Access Compliance Report

Public Rights-of-Way

(Curb Ramps)

Intersection ID: 18567	Main Street: MICHAEL_BAKER_PL	Cross Street: RUNNYMEDE_LN	Location: NW
ADA ID: 9AB16D82A94A	Ramp Type: BlendTrans1	Initial Pass/Fail: Fail	Overall Compliance: No
		Severity Score: 12.5

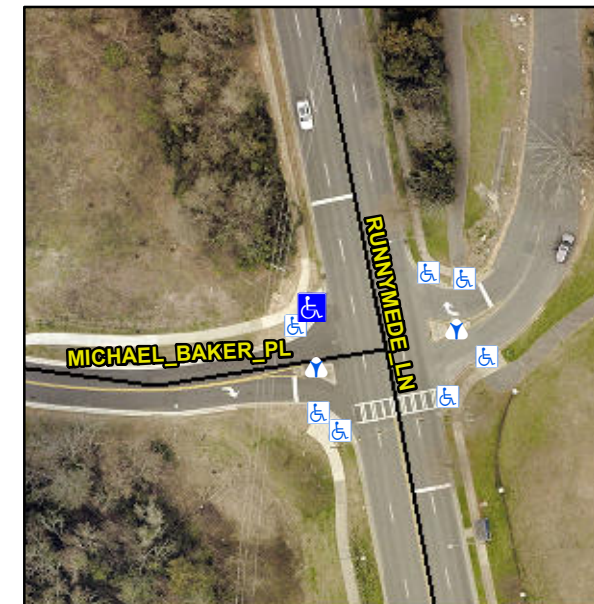
Not Found, R304.5.3

Remove & Replace Curb Ramp With Two New Directional Ramps or Equivalent.
